NORTHEAST UTILITIES

Millstone Nuclear Power Station, Unit No. 3
Structural and Geotechnical
Engineering Branch
Additional Information in Response
to Confirmatory Items

Attachment I

Revised Responses to Structural Audit Items:

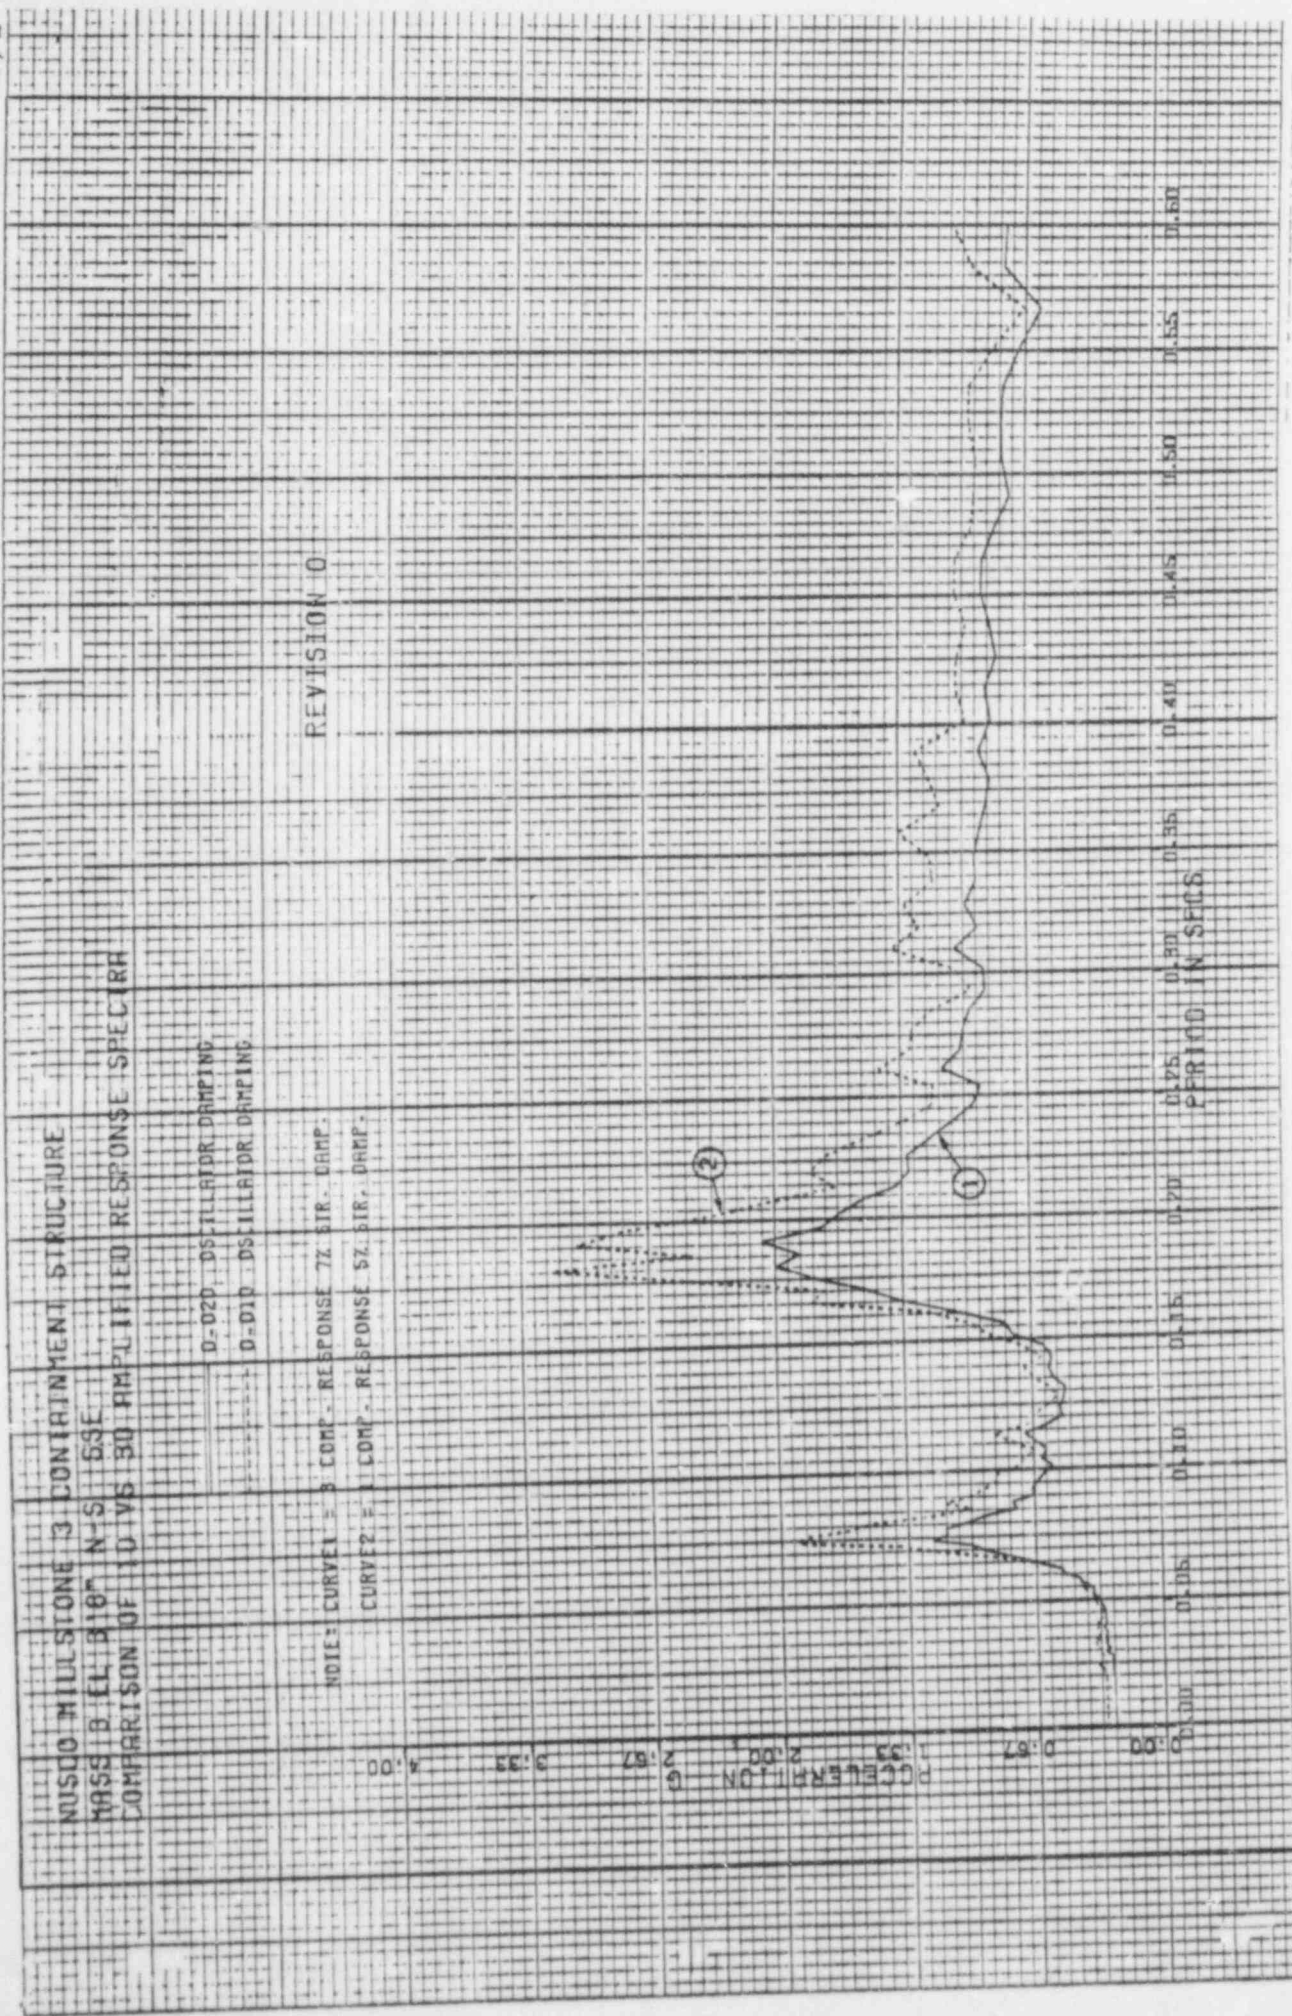
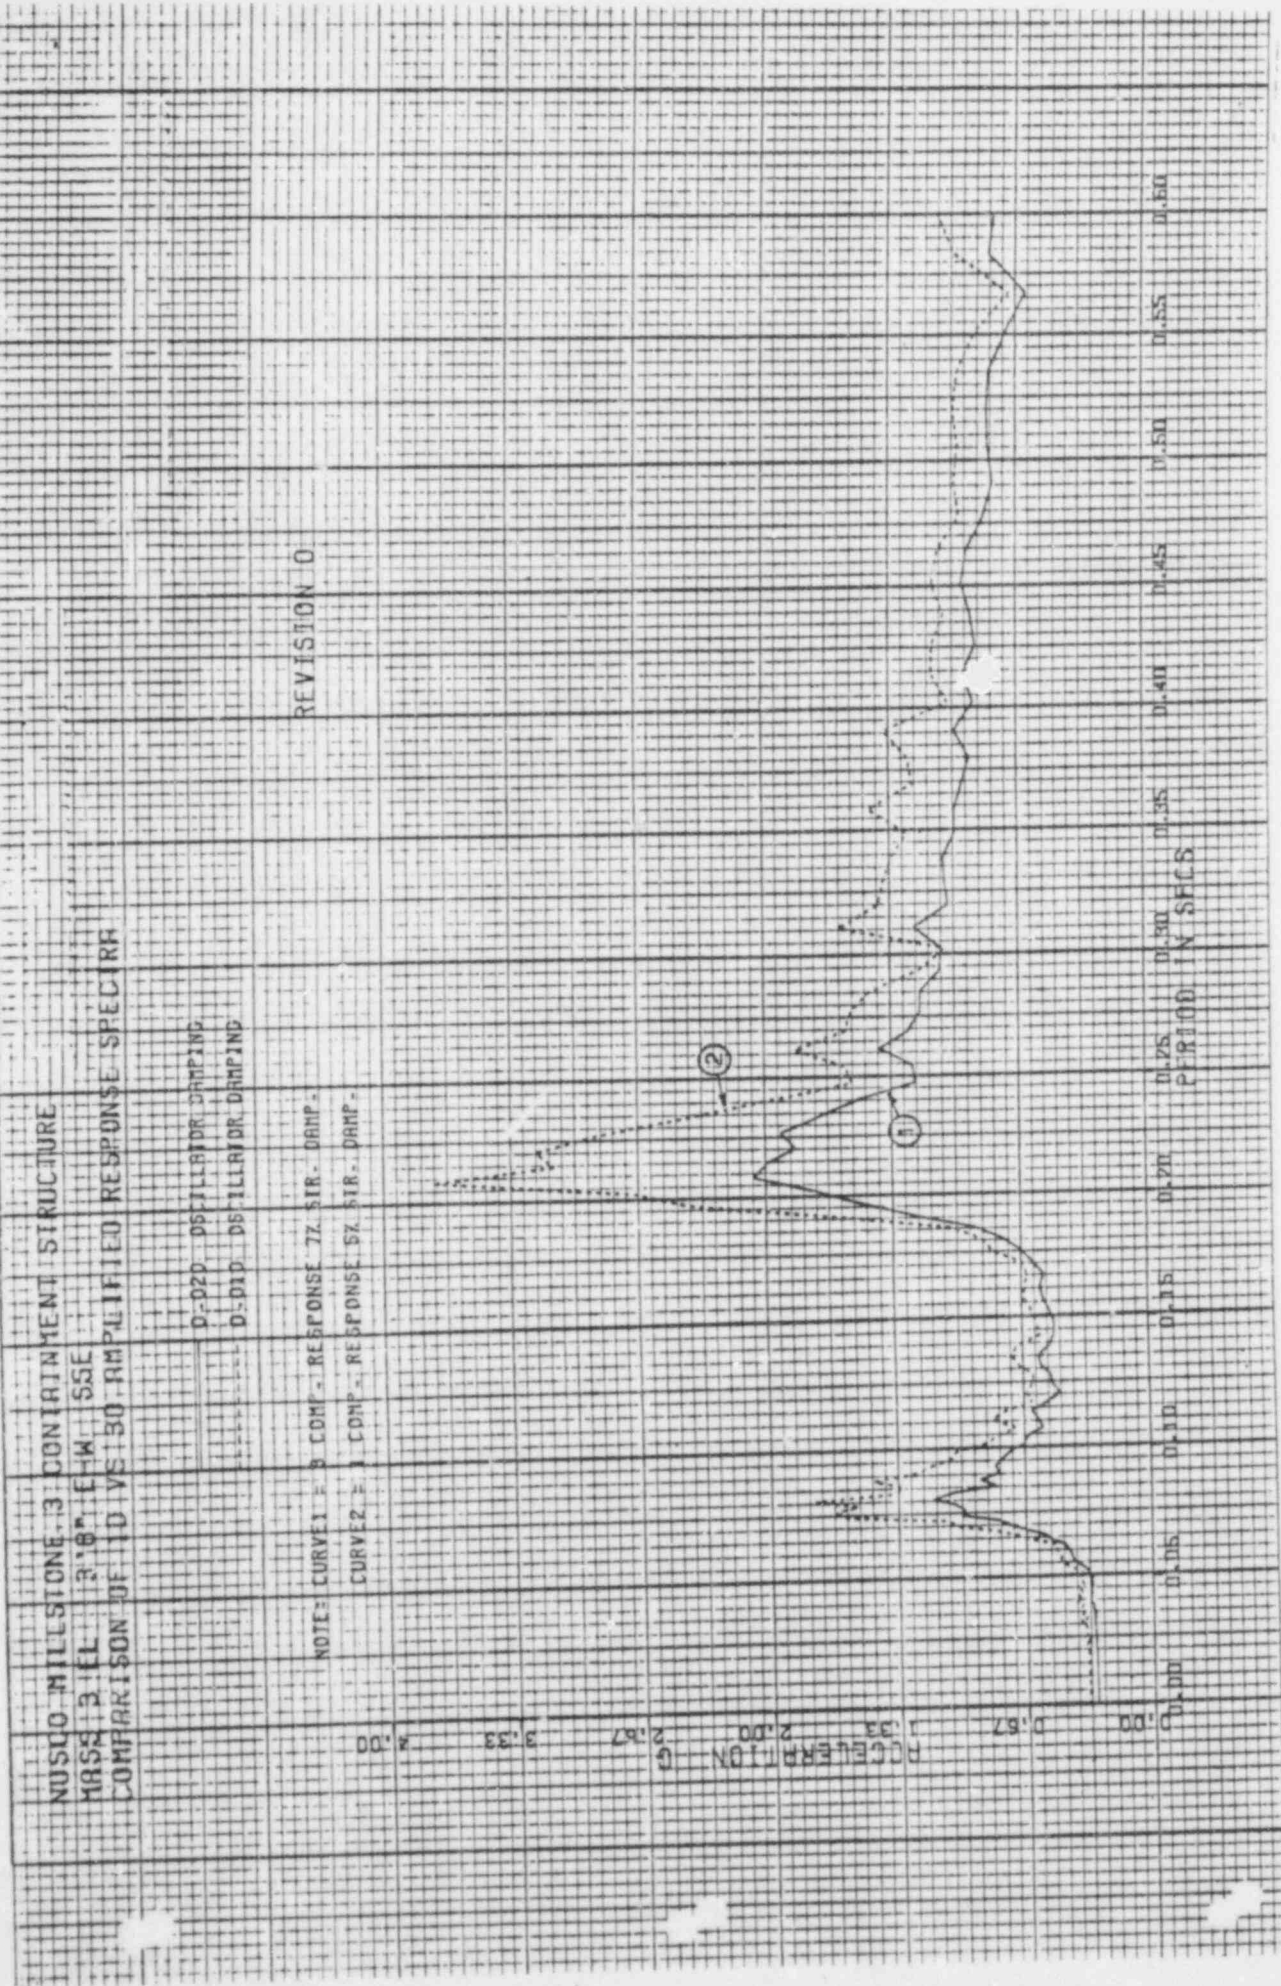
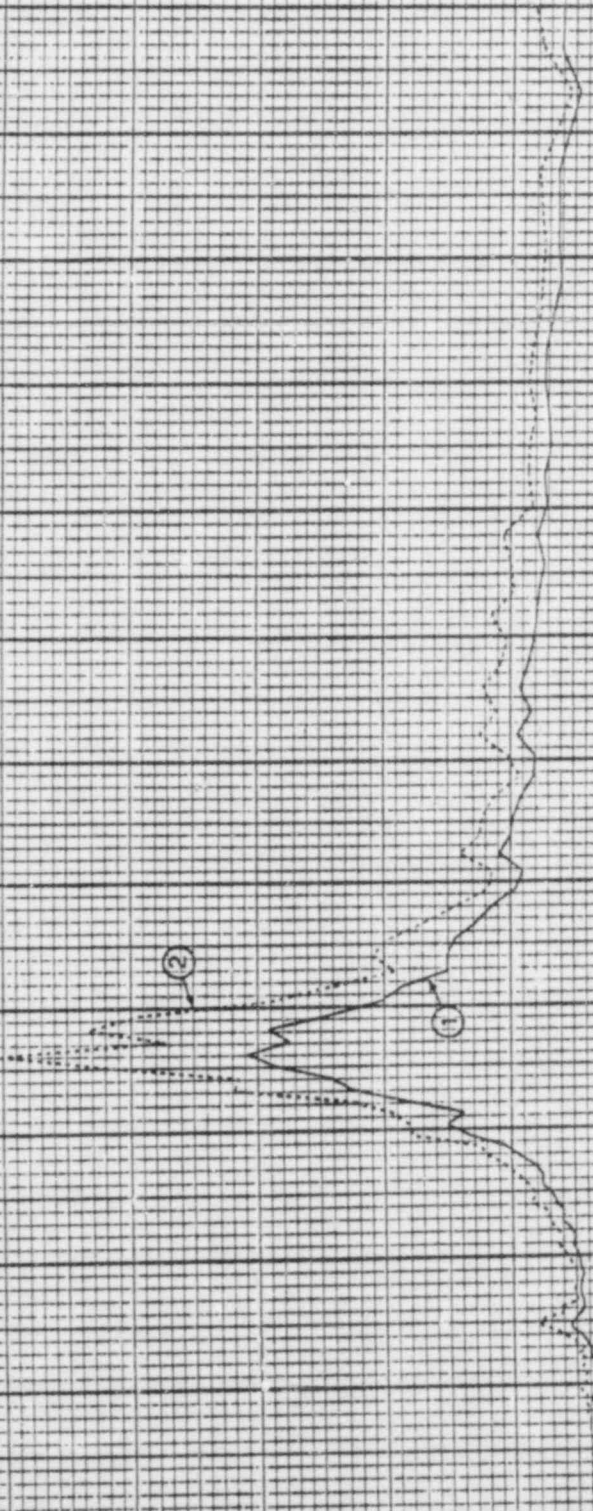
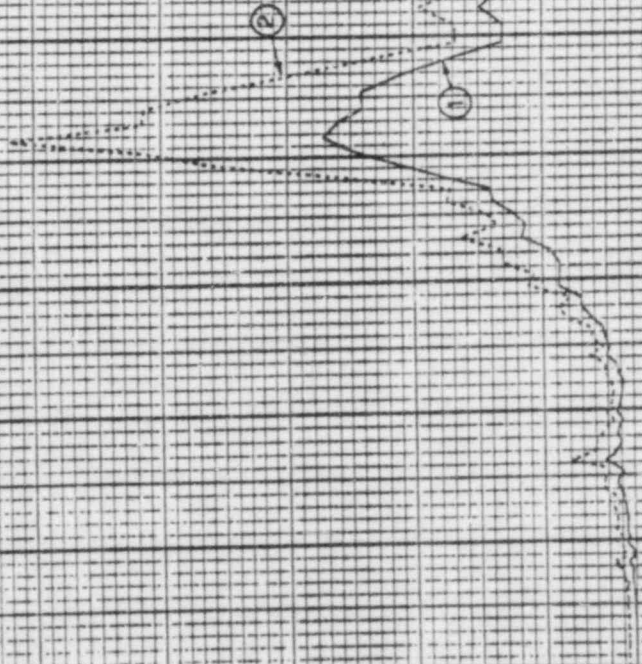
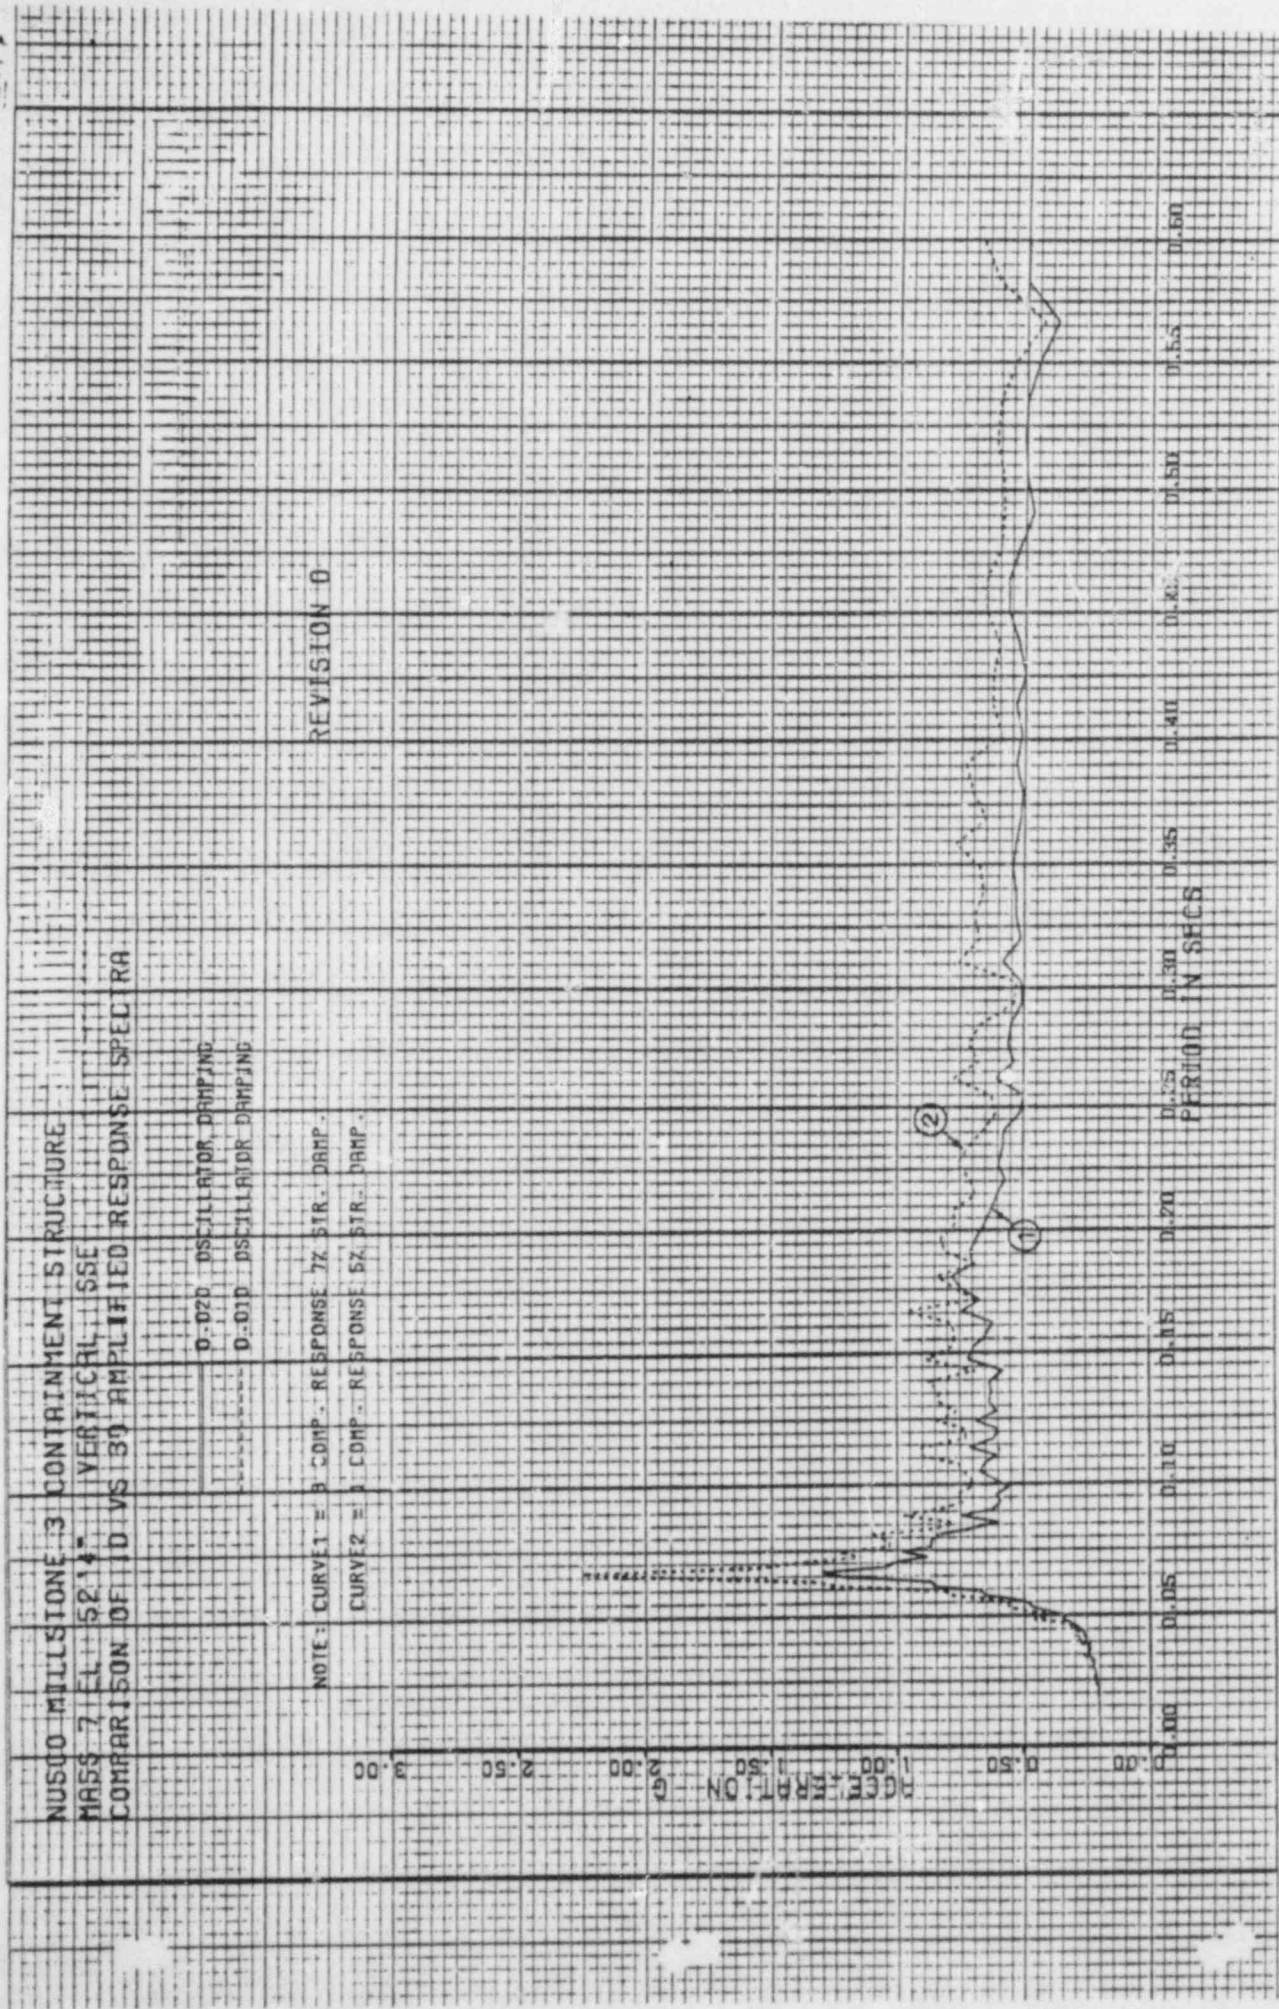
ITEM 27: Provide Justification for Generation of ARS Based Upon One
- Component of Input Motion

The method and criteria used in the generation of ARS for Millstone Unit 3 are inherently conservative. Conservative damping values are used both for structures and equipment. The conservatism in those damping values can be seen when they are compared with the recognized conservative values in Regulatory Guide 1.61. In addition, the input time history used to generate the ARS envelopes the design response spectrum as shown on Figures 3.7B-3 through 3.7B-8 of the FSAR.

To evaluate the conservatism of the one-component ARS curves, a study was conducted to provide a comparison between ARS developed for the SSE condition using:

1. One-component response with 5 percent structural damping and 1 percent oscillator damping.
2. Three-component response (SRSS of the three ARS components) with 7 percent structural damping and 2 percent oscillator damping.

To assure a study representative of all Category I buildings, the Containment Structure, Auxiliary Building, and Fuel Building were evaluated. The Auxiliary Building is representative of all Category I buildings with little coupling, and the Fuel Building is representative of buildings with a large degree of coupling. In every case, the ARS were generated for SSE condition using the three-component response and are enveloped by the response spectra that have been used in piping and equipment qualification.

The attached amplified response spectra curves used in the study are provided for the above buildings in the direction of E-W, N-S and vertical excitation are as follows:

Therefore, it is concluded that the one-component ARS curves developed for all Millstone Unit 3 Category I buildings are conservative with respect to the three-component ARS curves.
